Glebe Island Expo

Interim Exhibition Facility

Submission by Leichhardt Council

Figure 11: The number 24 identifies the location of a billboard at the edge of the car park and facing towards Anzac Bridge (source: Woods Bagot).

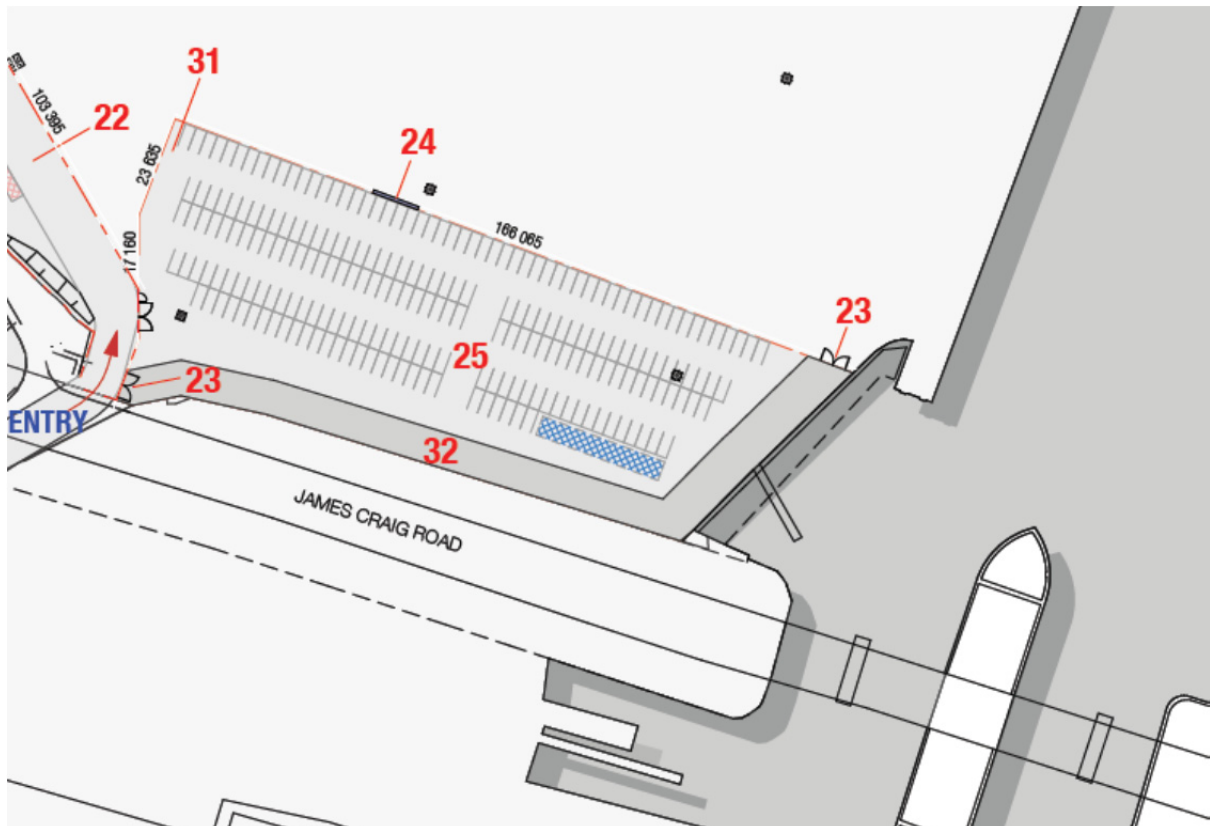
There are no details regarding lighting or illumination. There are no details of the location or illumination of building identification signage.

The size, height, positioning and illumination of signage is a matter that has not been adequately addressed in the DA and requires more detail. At the very least any approval should require that all lighting and illumination on the site meet relevant Australian Standards for light spill. Also illumination of buildings and signage should be restricted to business hours associated with the facility.
